**GENOA CHARTER TOWNSHIP
PLANNING COMMISSION
PUBLIC HEARING
JANUARY 12, 2015
6:30 P.M.
AGENDA**

Attention:	Kelly Van Marter, AICP Assistant Township Manager and Planning Director
Subject:	The Well Worship Facility and Coffee Shop – Sketch Plan Review #1
Location:	2250 Genoa Business Park Drive – northwest corner of Grand River Avenue and Genoa Business Park Drive
Zoning:	GCD General Commercial District

Attention:	Kelly Van Marter, AICP Assistant Township Manager and Planning Director
Subject:	Redevelopment of Livingston Commons Lot #4 – Site Plan Review #2
Location:	Southwest corner of Grand River Avenue and Latson Road
Zoning:	NR-PUD Non-Residential Planned Unit Development District

Re: Livingston Commons Lot 4 Redevelopment Site Plan Review # 2

SHEET **C-3.0**

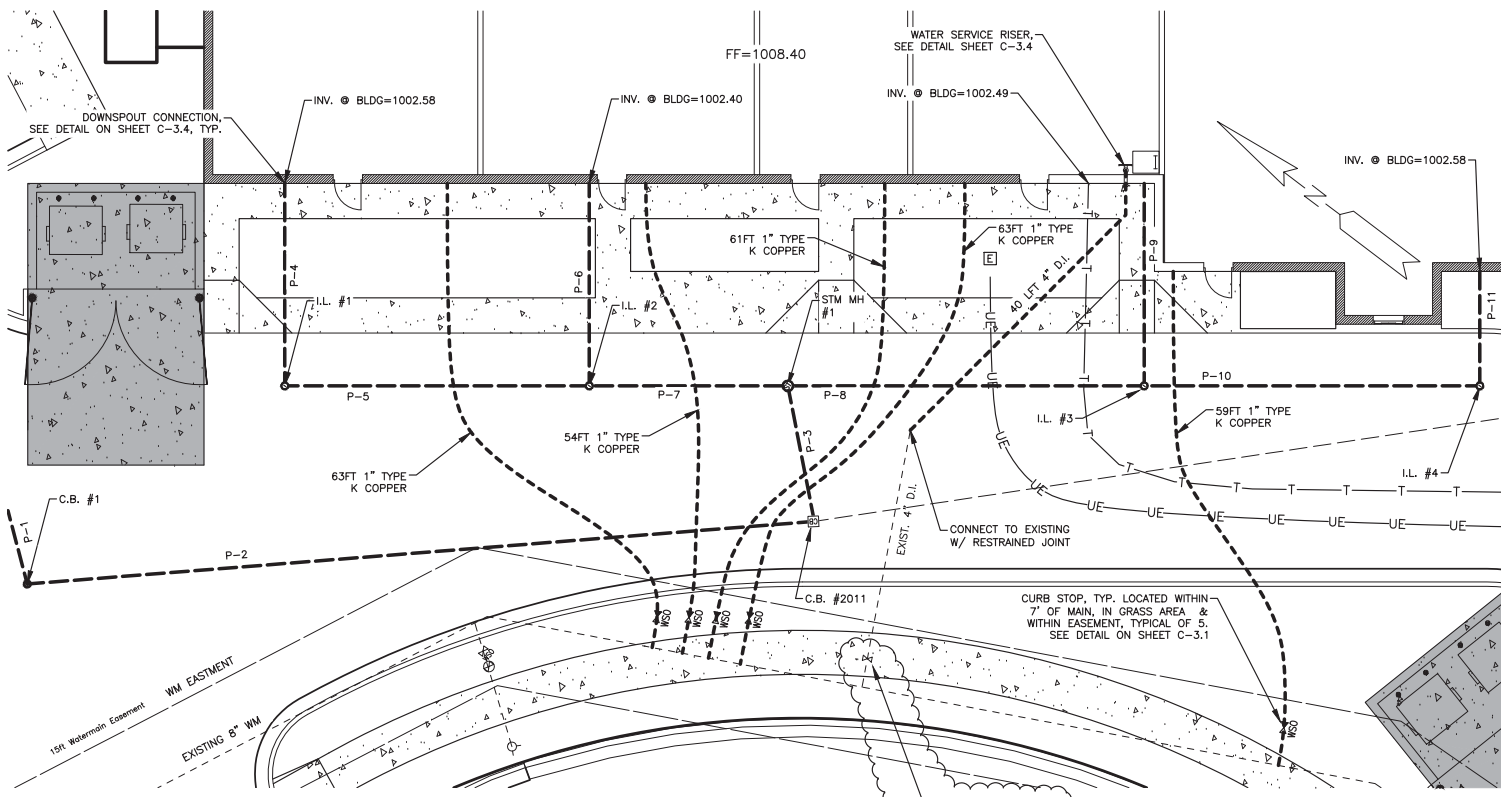
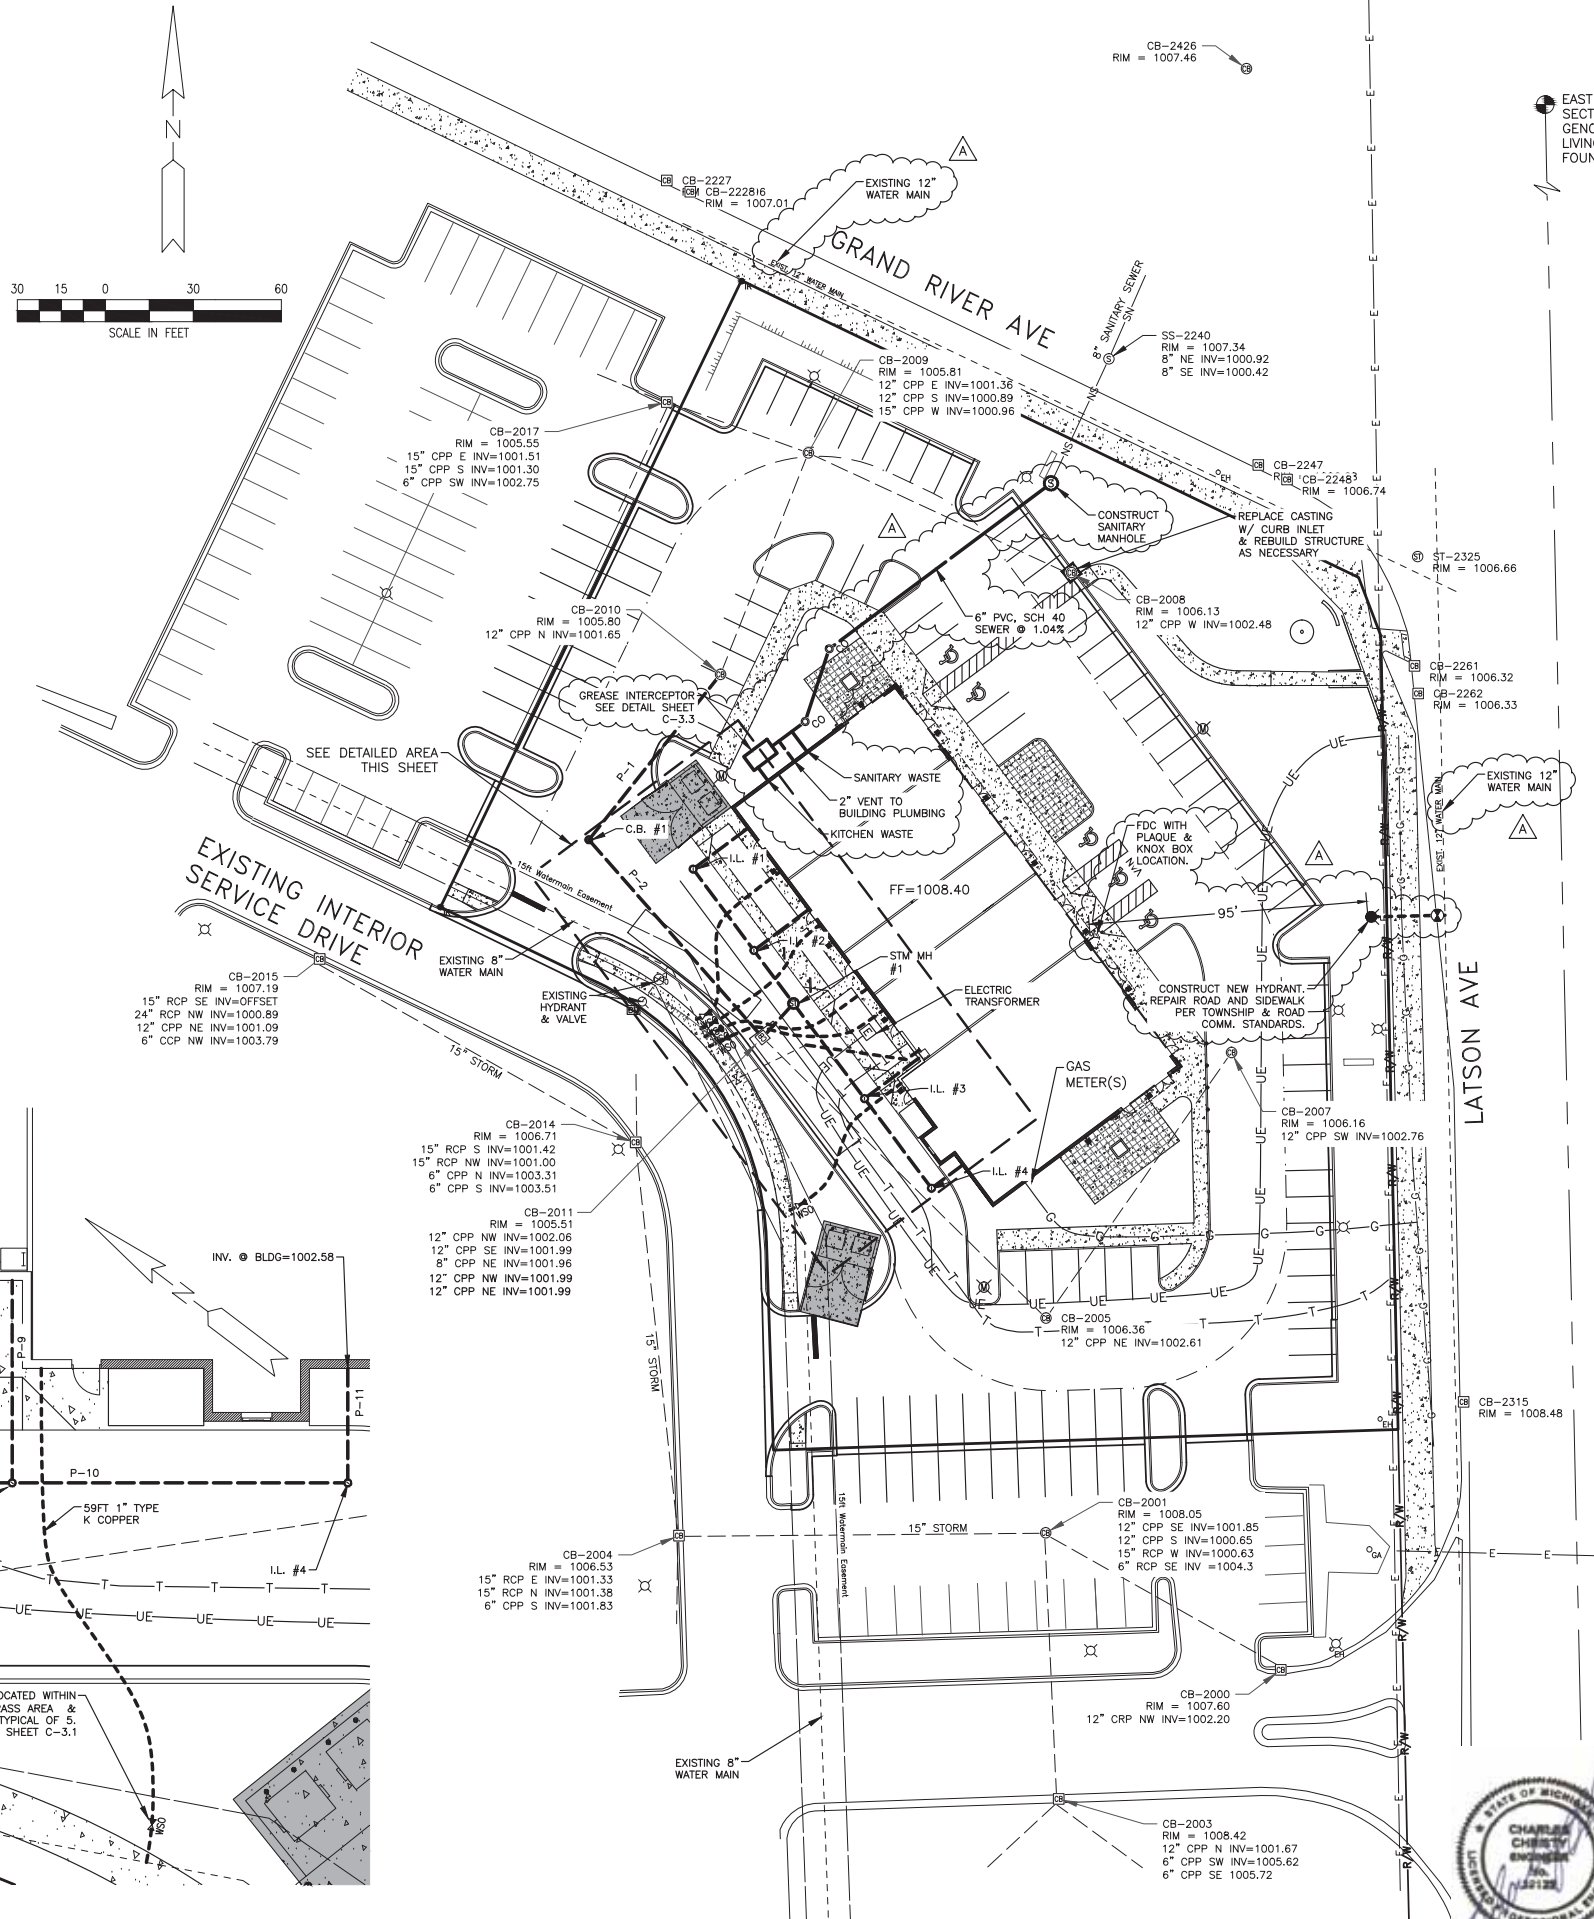
1. The updated plans include a hydrant on the east side of the building, per the fire department review. MHOG records indicate that there is no 12-inch water line adjacent to the curb line along the north and east sides of the site. Recommend installing a tapping sleeve and valve off the water main that runs along the western side of the lot and extend the water main around the south side of the building to the proposed hydrant location. This new water main will become a public main and an easement will be required, per MHOG standards. Construction plans for the public water main must be reviewed by MHOG. Petitioner will be required to include a completed permit application with the construction plan review

1. To achieve proper spacing and placement, an additional fire hydrant is required to be installed on the Grand River side of the property. Provide the location of the water main to be looped around the building and the new hydrant location. (Hydrant is to be placed on the grassy peninsula located along Latson Rd. between Grand River and southeast corner of the parking lot). This hydrant shall be located within 100' of the approved location for the fire department connection. **(Corrected by installation of new hydrant to be placed on the Latson Rd. 12" water main; previously unidentified on plan)**
IFC 912.2

- B. The size of the fire protection lead and gate valve shall be indicated on the utility site plan. Gate valve is to be controlled with curb box rather than PIV. **(Lead size is cited as a 4". Fire protection leads shall be a minimum 6" to meet the size, design and installation requirements of the MHOG Water Authority.)**

SHEET C-6.0

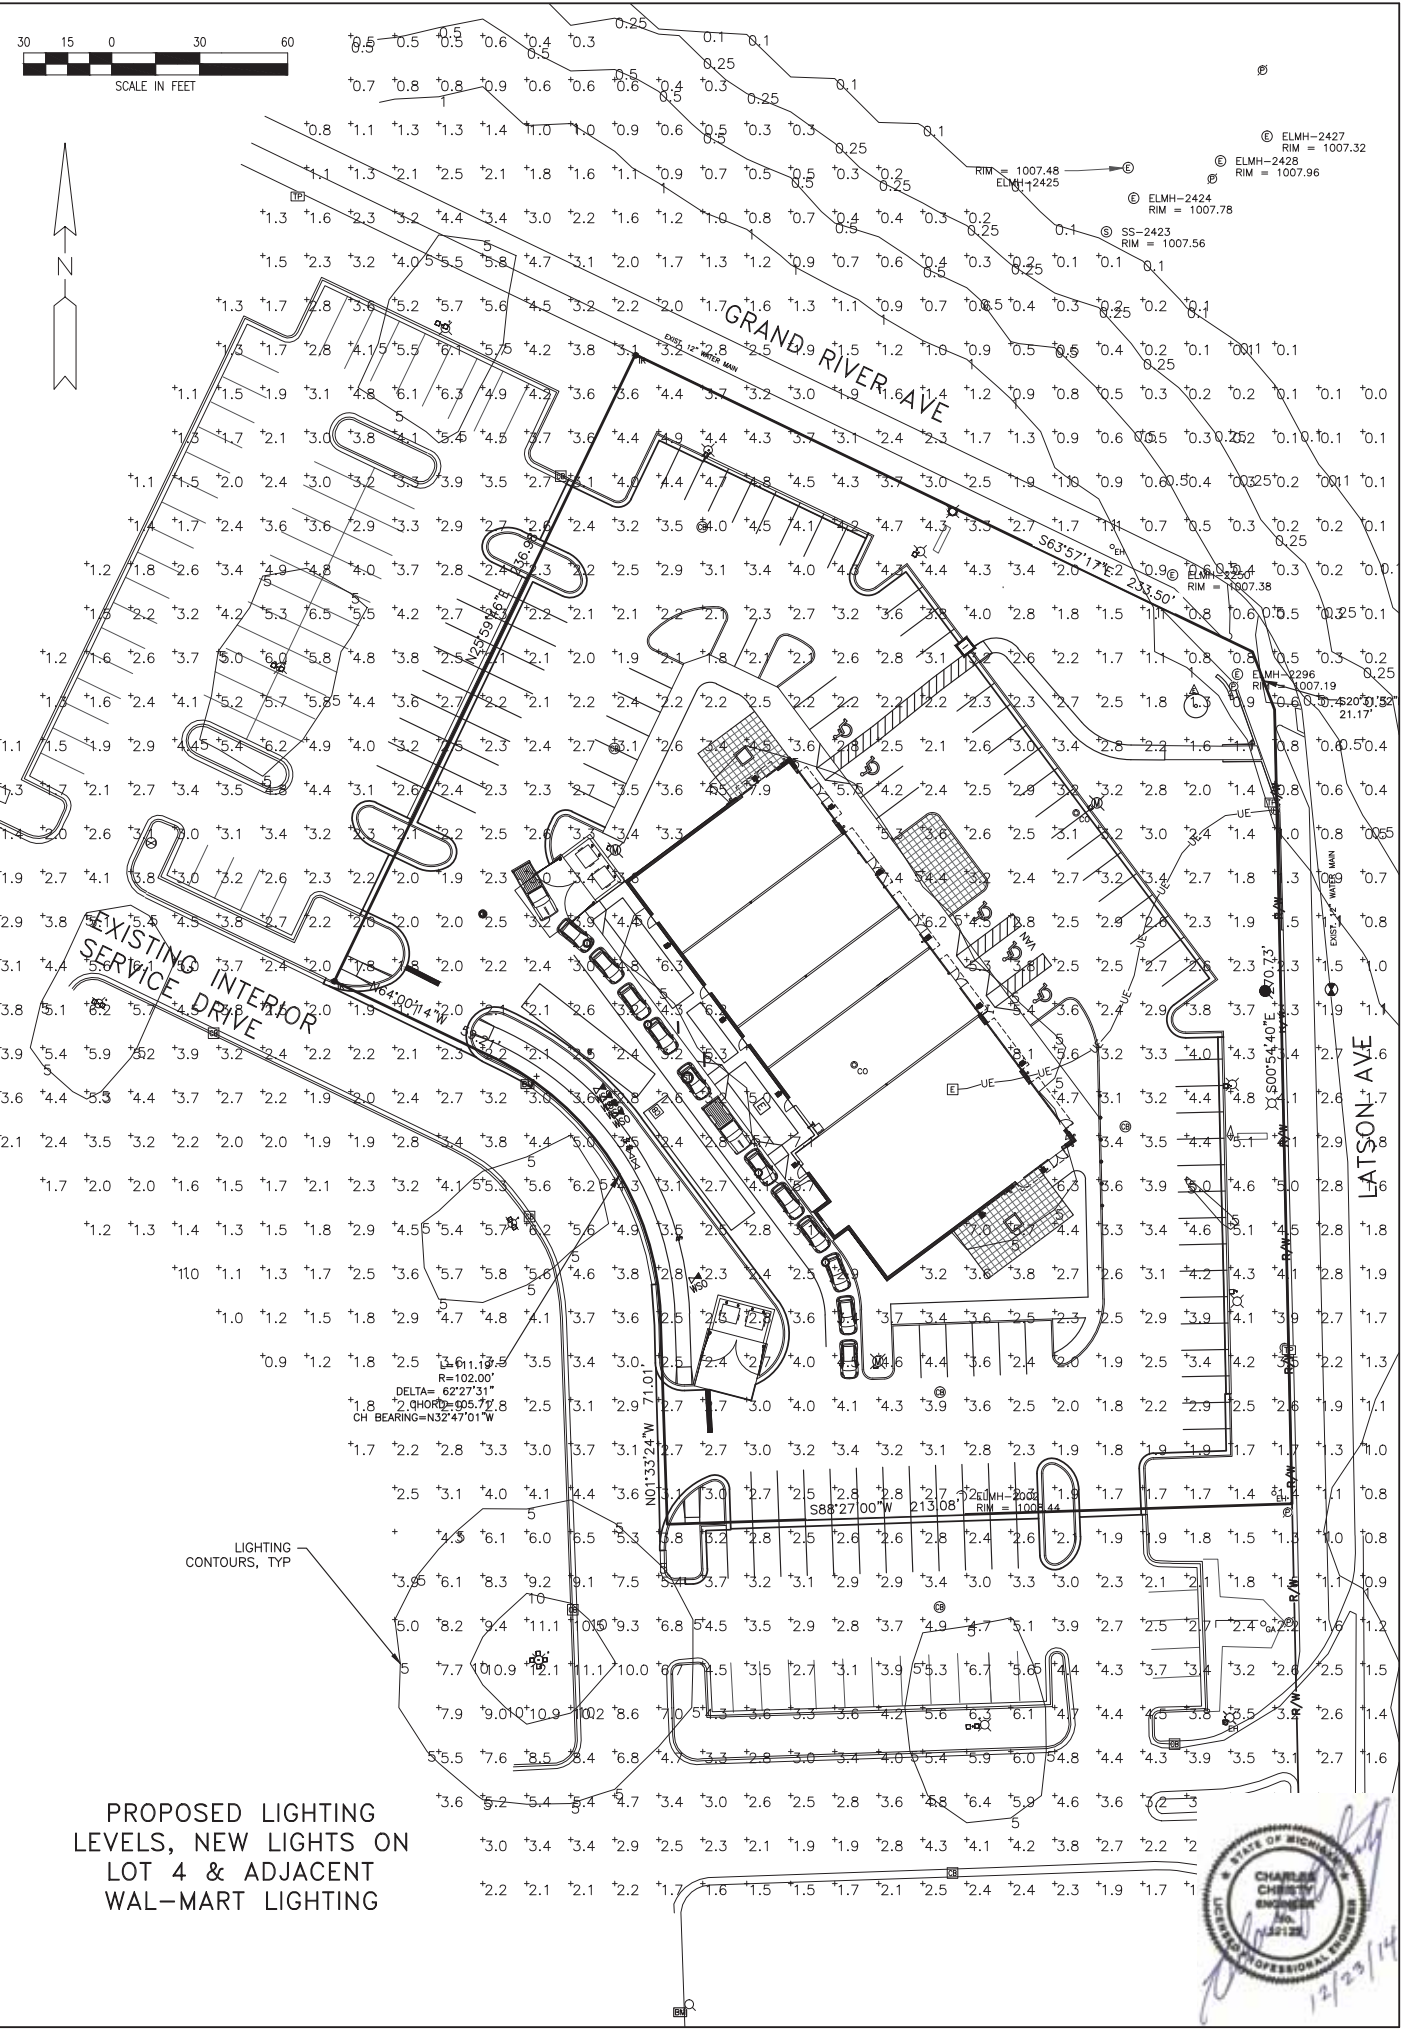
9. Exterior Lighting. The submittal includes a lighting plan (Sheet C-6.0), which proposes the installation of 3 new light poles, 4 new light fixtures on existing poles and 12 wall mounted fixtures. The details and photometric readings on Sheets C-6.0 and C-6.1 are all in accordance with the requirements of Section 12.03.

EAST ELEVATION
SCALE: 1/8" = 1'-0"

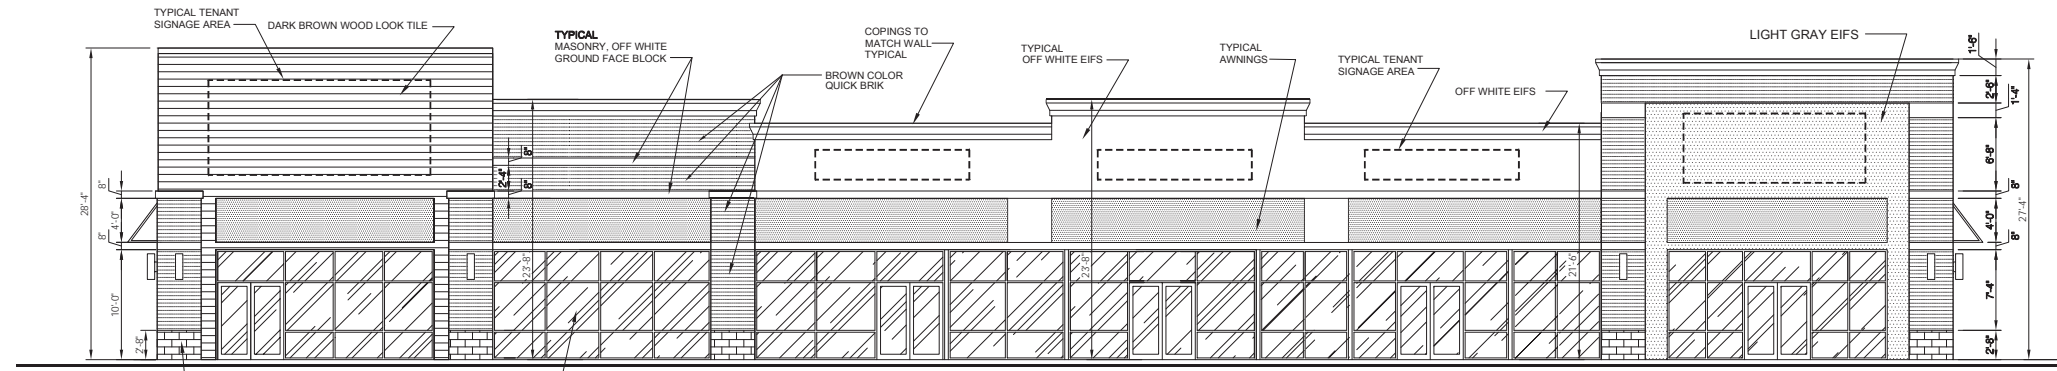
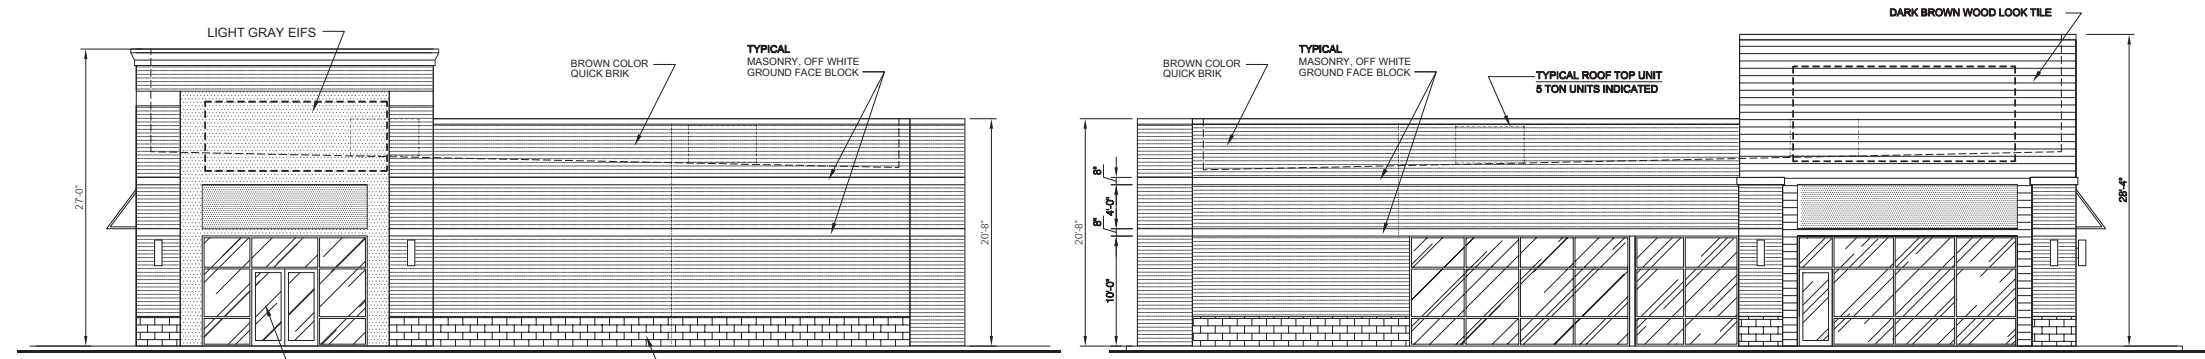
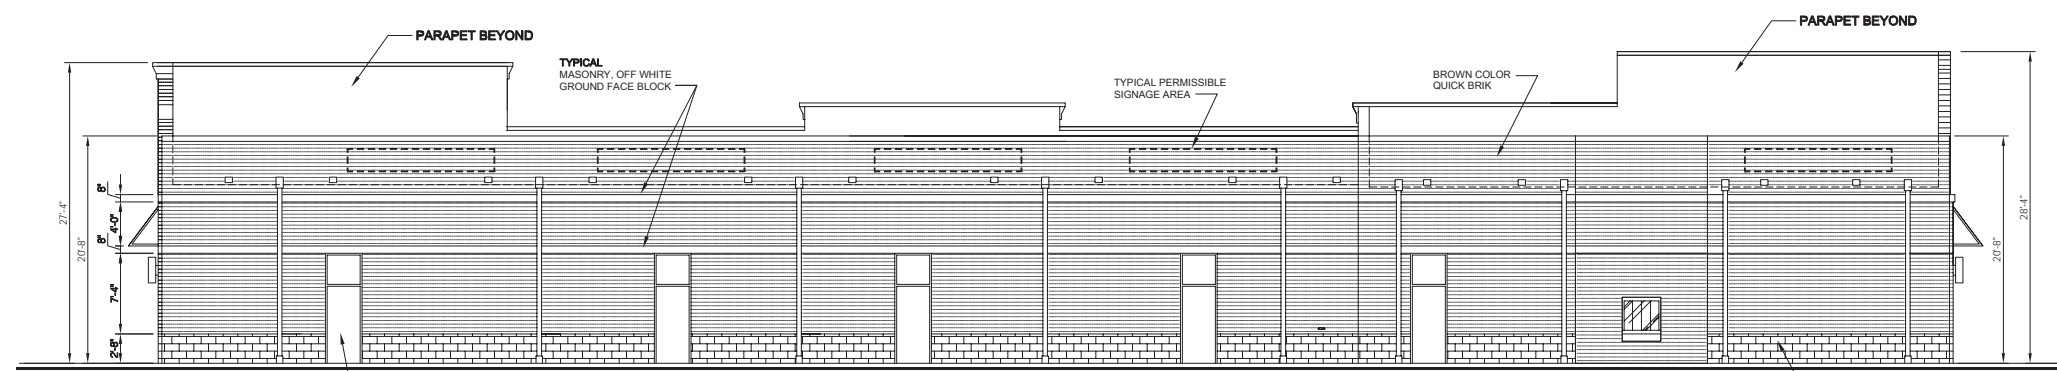
8. We recommend the applicant include a note on the building elevation drawing clarifying the number of wall signs for the end units.
9. We suggest the Township require details of typical outdoor patio elements at such time as each tenant seeks to use the outdoor dining spaces.

We are of the opinion that the front façade contains too much EIFS, particularly given the highly visible location. The PUD Agreement requires 80% of building wall surfaces to be natural materials (such as brick or stone). In response, the applicant notes that 86% of the building is comprised of such materials; however, we do not believe the front façade meets this standard.

Given the site's presence as a corner lot, 2 wall signs are permitted for each business and the Planning Commission may permit 2 monument signs; however, there is nothing in the Ordinance or PUD Agreement that permits a 3rd wall sign for a business. In response, the applicant has indicated that the intent is for the tenants of the end units to pick 2 out of the 3 wall sign options. In order to avoid any confusion in the future, we recommend the applicant add a note to this effect on the building elevation drawings.
